CENTERVILLE CITY PLANNING COMMISSION AGENDA

Short Title: Public Hearing - Conceptual Site Plan Amendment, South Davis Metro Fire Station 83

**STAFF REPORT
AGENDA: ITEM 1**

Re: NEW CENTERVILLE FIRE STATION #83 PROPOSED WALK AND LANDSCAPE REVISIONS ALONG MAIN STREET

Island View Park Renovation Phase 2 Conceptual Plan

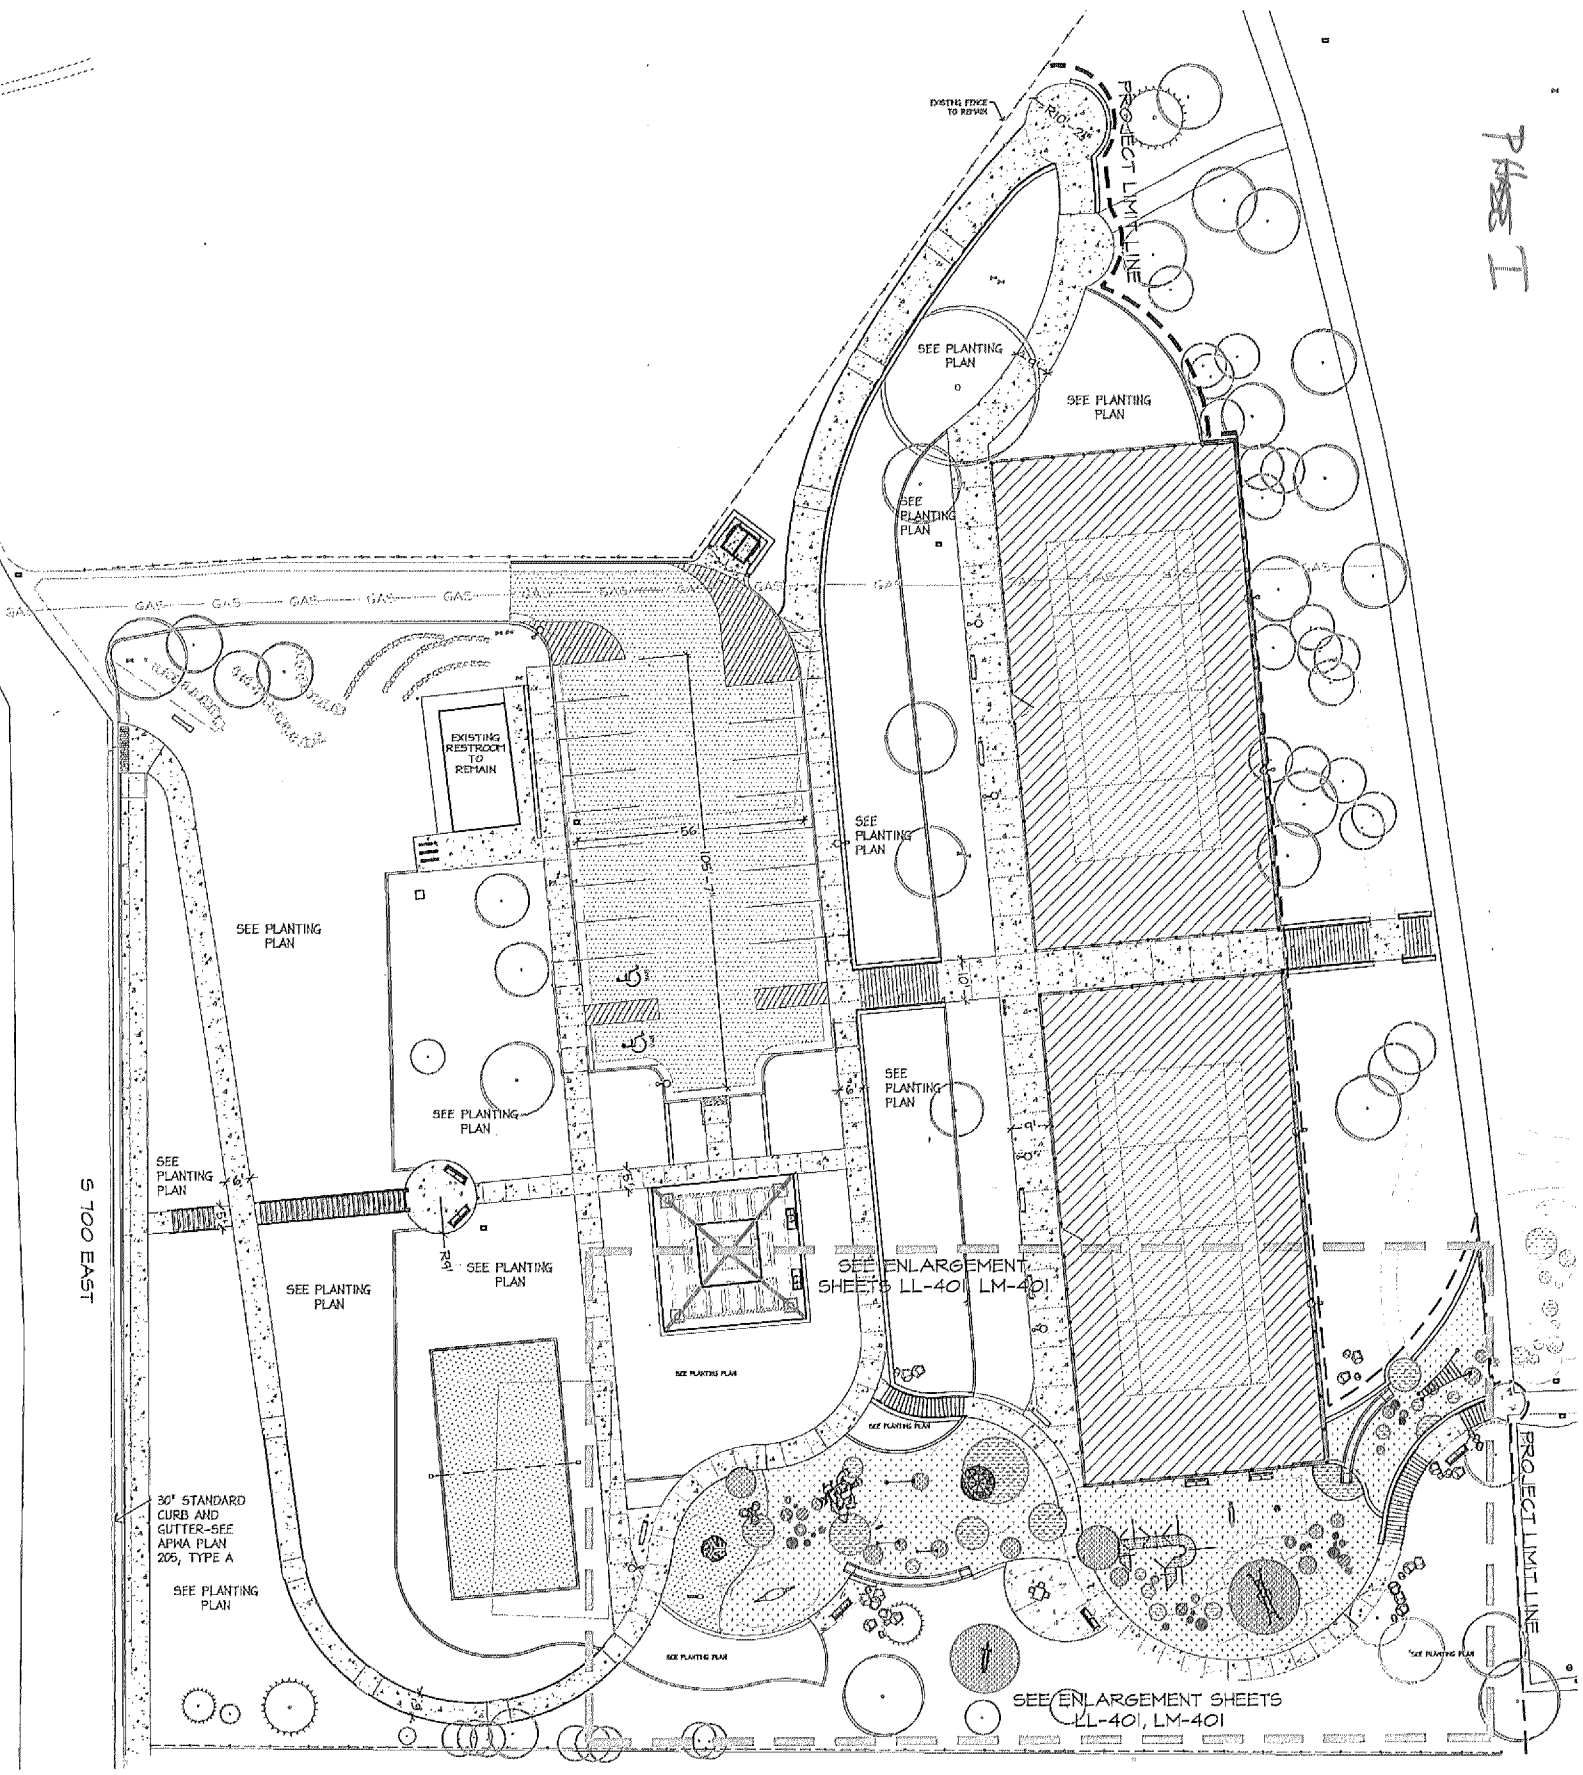
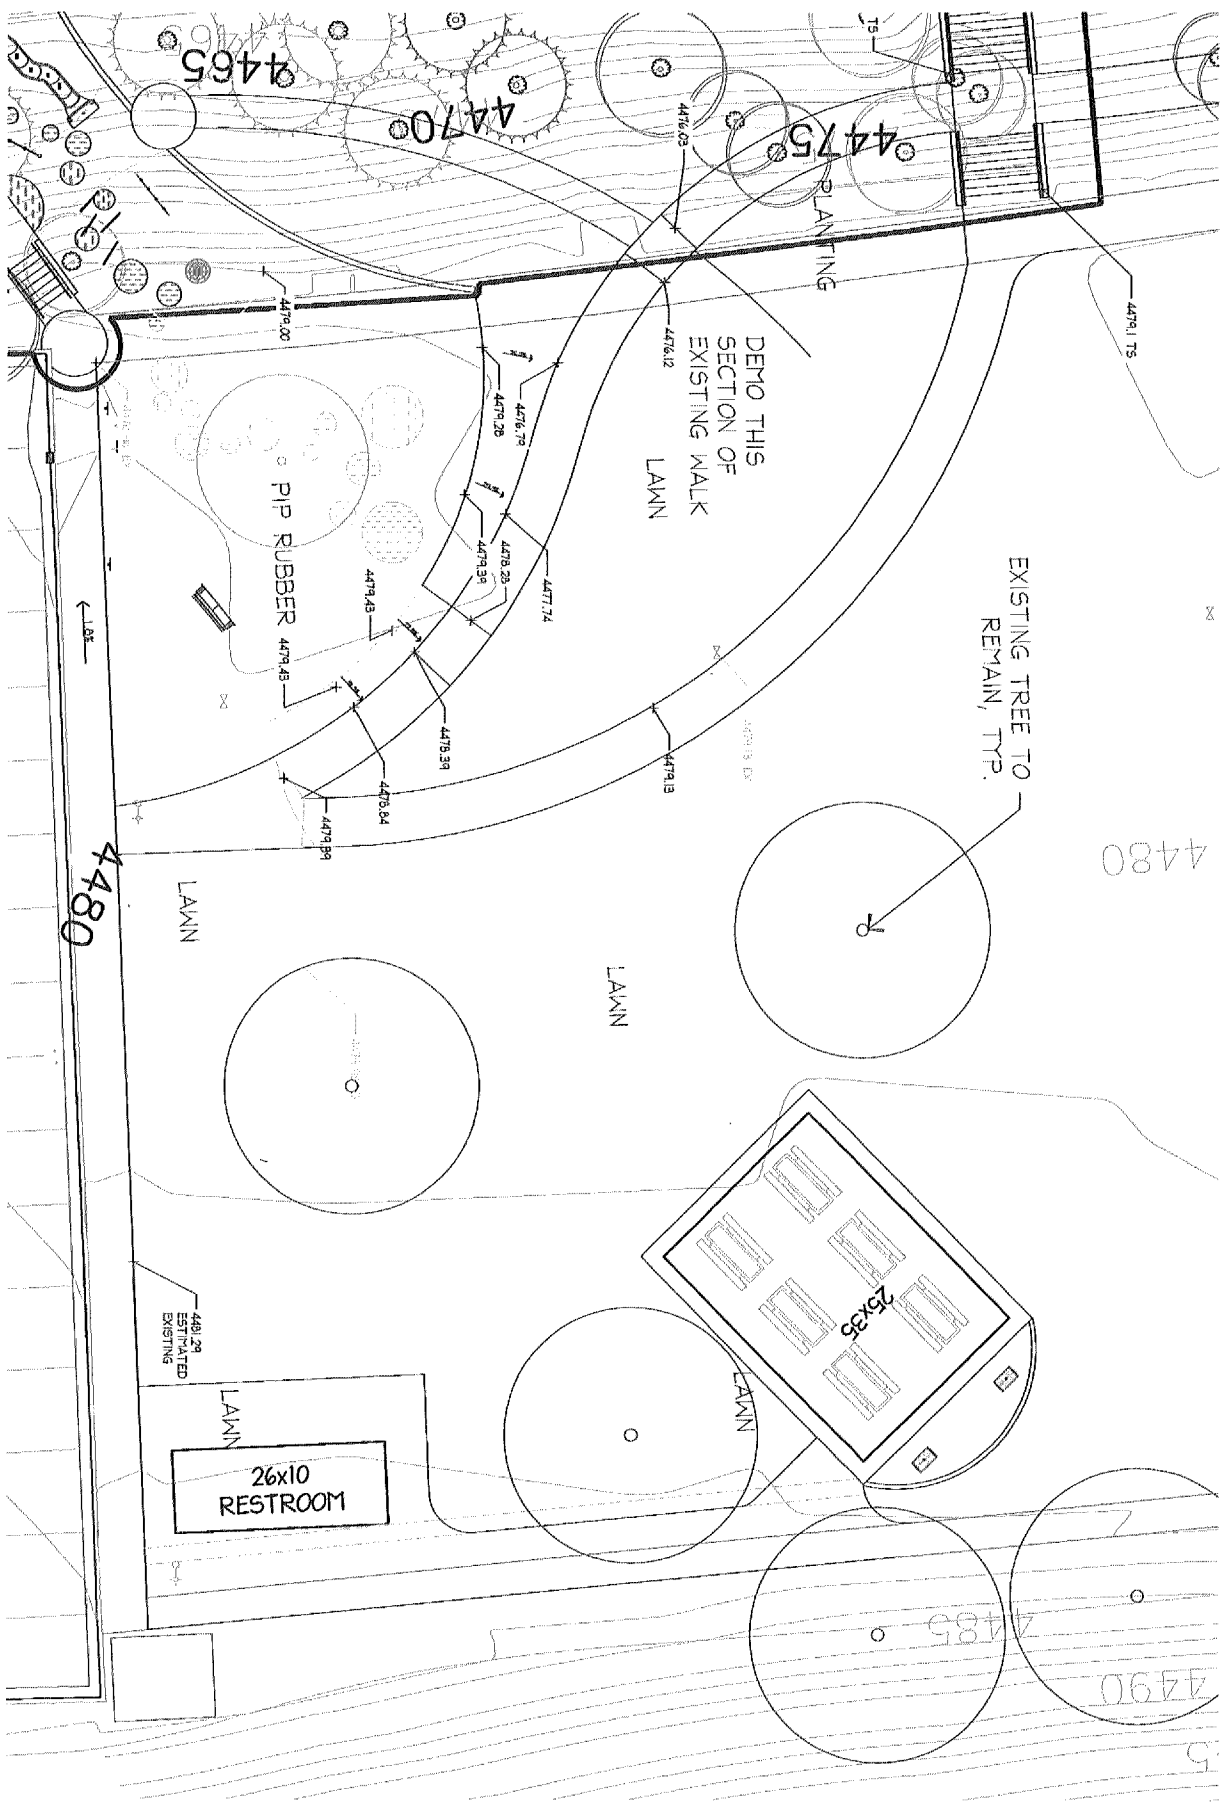
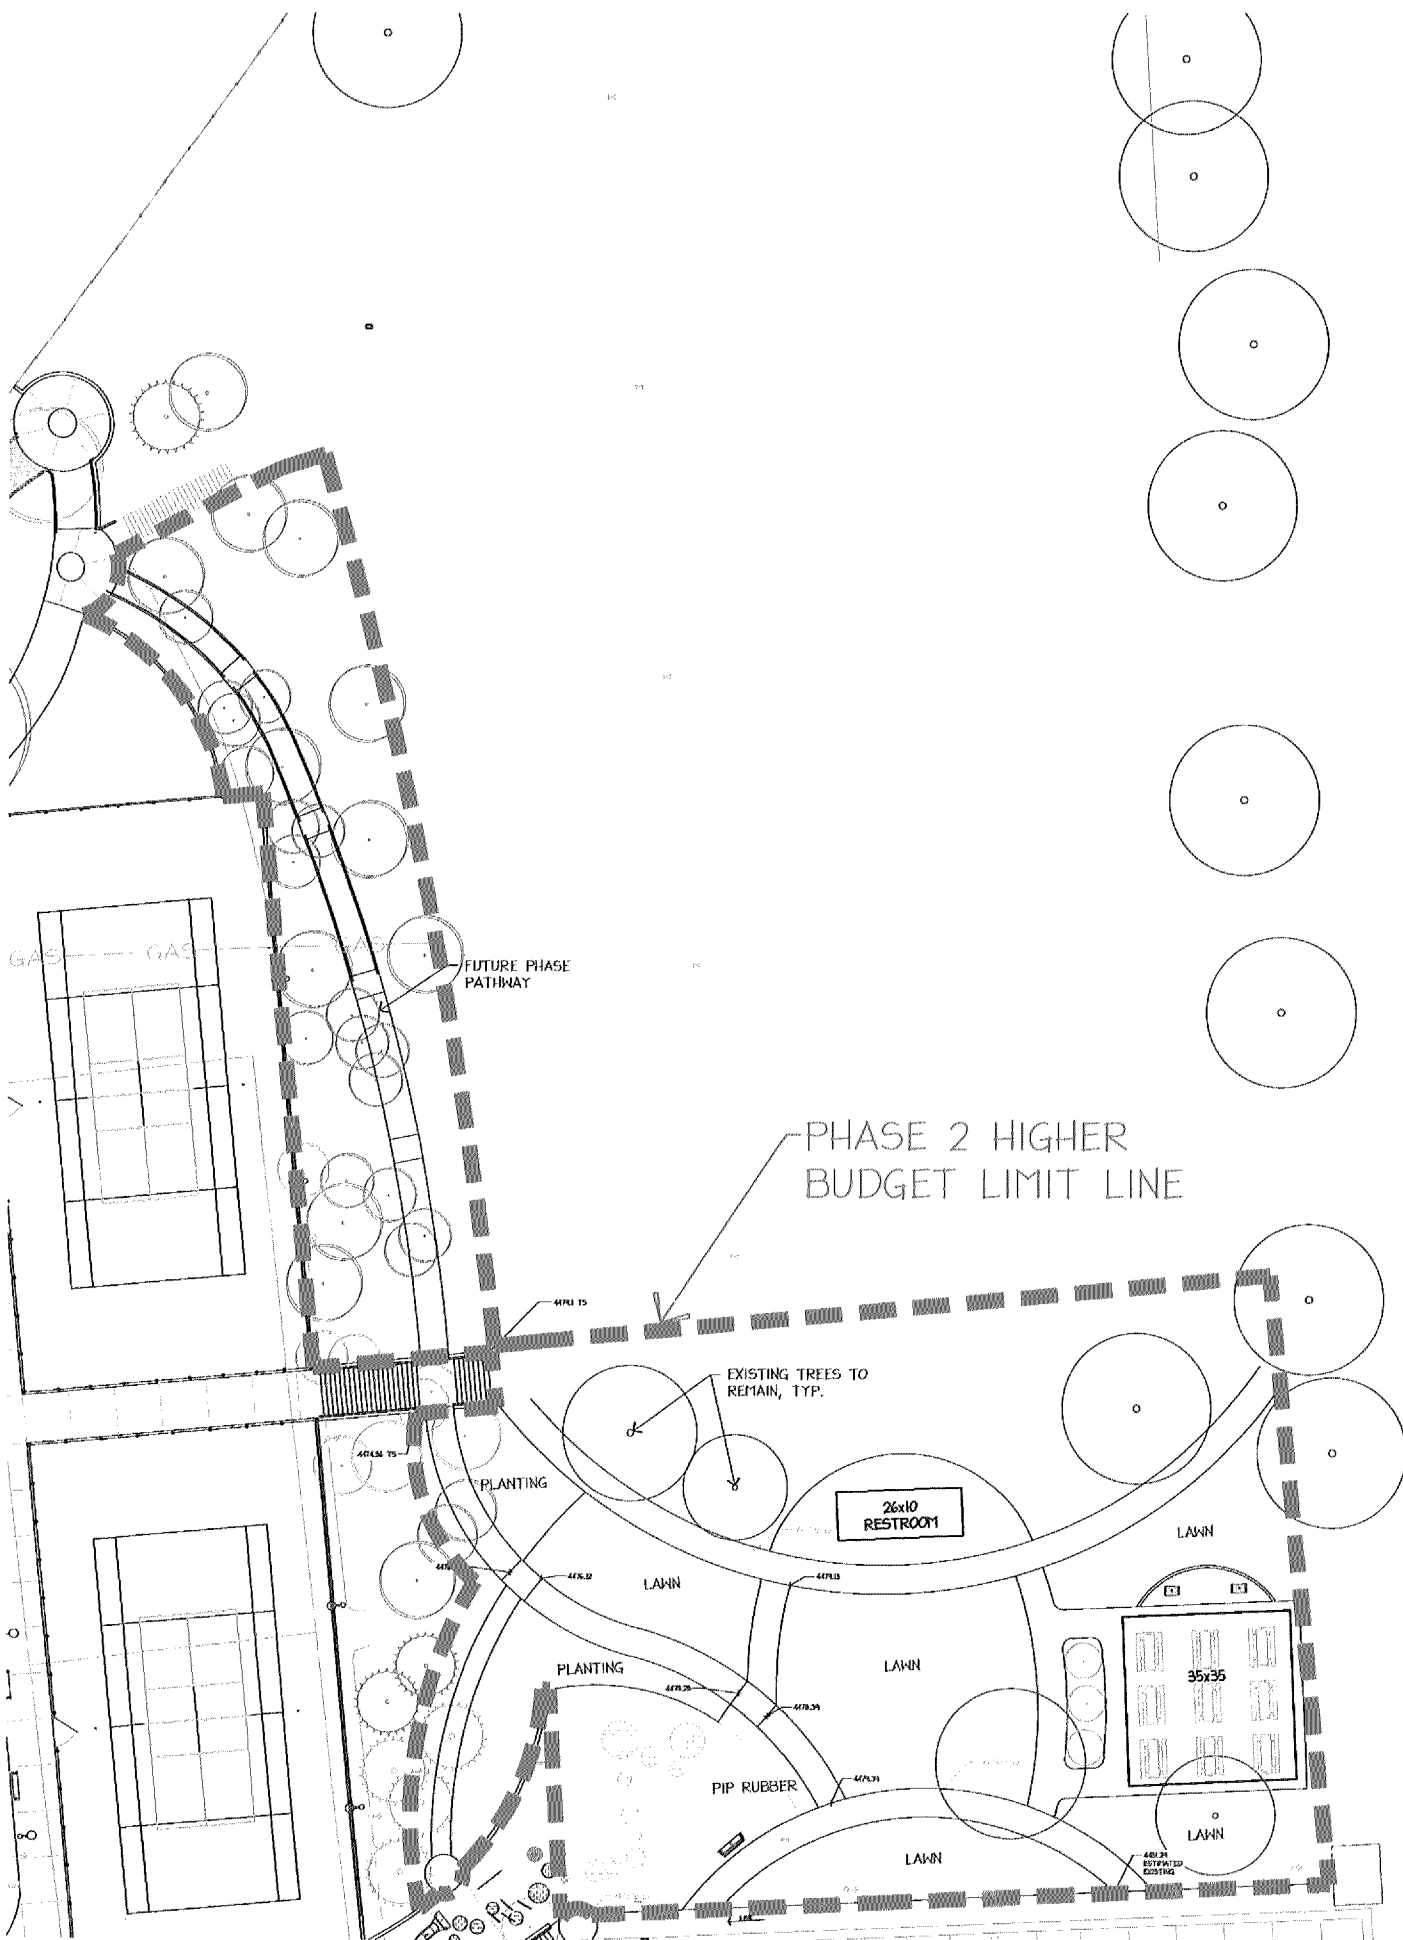
CZC 12.55.110 Fences and Walls – It appears most of the existing fence for the park (*around the perimeter*) will remain in place. Any new fencing shall meet the applicable height limitations of 4 feet in any front yard area and 6 feet all other yard areas, unless otherwise submitted to the Planning Commission for approval (*up to a maximum height of 10 feet*).

CZC 12.55.140 Outdoor Lighting – The submitted plan depicts several lighting elements. The ordinance requires that the fixture design must include the use of external/internal shield to direct the light downward and/or away from residential homes.

CZC 12.52.300 Off-street Parking Schedule – The site plan depicts the removal of the parking located along 700 East (*will become part of the park expansion*) and expanding the existing parking lot interior to the park. Parking count will total at 19 stalls. According to the parking schedule, a “Parking Study” is required (*see CZC 12.52.110.e for study requirements*). This study will need to be performed and submitted as part of the Final Site Plan review and approval.

CZC 12.54.080.2 Public Facility Zone Signs – The plan notes that the existing sign will be relocated. The new sign must meet the sign area requirements, which is limited to a maximum area of 75 square feet.

- 1. The park renovation may seek a phasing approach, as part of the Final Site Plan submittal.*
- 2. Any new accessory building (e.g. pavilion, restrooms, etc.) must not exceed an average building height of 20-feet, as measured to the mid-point of the roof.*
- 3. Any new accessory building must not have a floor area larger than 1,000 square feet.*
- 4. The City Engineer will need to review the plans in regards to storm water management and verify compliance with city specifications.*
- 5. Any new fencing must meet the applicable height limitations of 4 feet in any front yard area and 6 feet all other yard areas, unless otherwise submitted to the Planning*

- 6. All lighting fixture designs must include the use of external/internal shield to direct the light downward and/or away from residential homes.*
- 7. A "Parking Study" is required (see CZC 12.52.110.e for study requirements). This study must be performed and submitted as part of the Final Site Plan review and approval.*
- 8. The new sign must meet the sign area requirements, which is limited to a maximum area of 75 square feet.*
